BULLETIN: T-62-42

SUBJECT: Bumper Control Strap TR-4
(Commission No. 5000 and up),
and all TR-3b's.

STANDARD-TRIUMPH MOTOR COMPANY, INC.

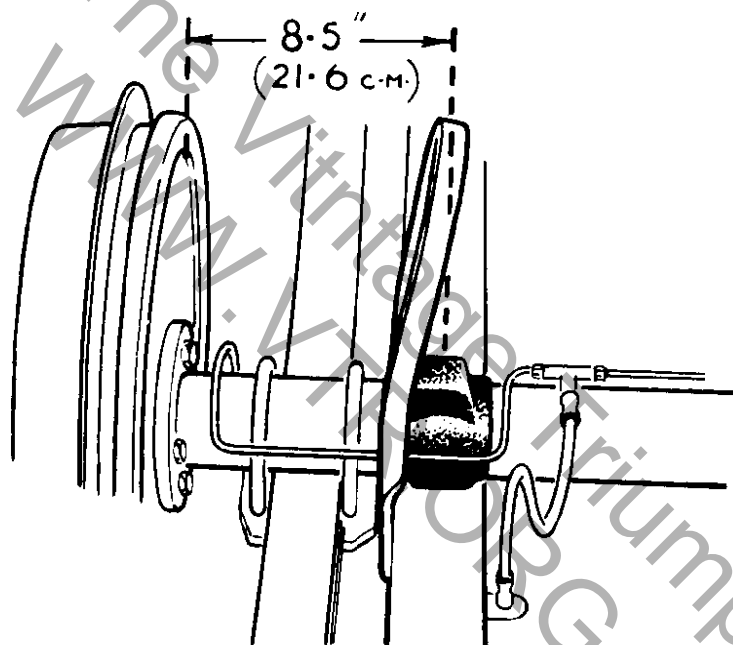
A considerable variation in position may exist from car to car and all straps should be reset by hand to a distance of 8-1/2" (21.6 cm) from the outer top edge of the strap to the inner top face of the brake back plate.

Under full bump conditions, unless this bump control strap is in the correct position, it is possible for the control strap to foul the brake pipe from the three-way connection to the offside rear wheel cylinder.

When checking the bump control strap, it is IMPERATIVE that inspection be made of brake pipe part #208286 which leads from the three-way connection to the right rear wheel brake cylinder. It is important to do this as it is possible there is already damage to the brake tube at the point where the brake tube leads from the three-way connection. It will be necessary to remove the brake pipe part #208286 to inspect the pipe for damage which may already have occurred and which ordinarily would be concealed by the pipe nut.

We are attaching a drawing showing the proper location of the bump control strap and the pipe nut on the three-way connection which must be unscrewed in order to check the brake pipe which leads from the three-way connection to the right rear wheel brake cylinder.
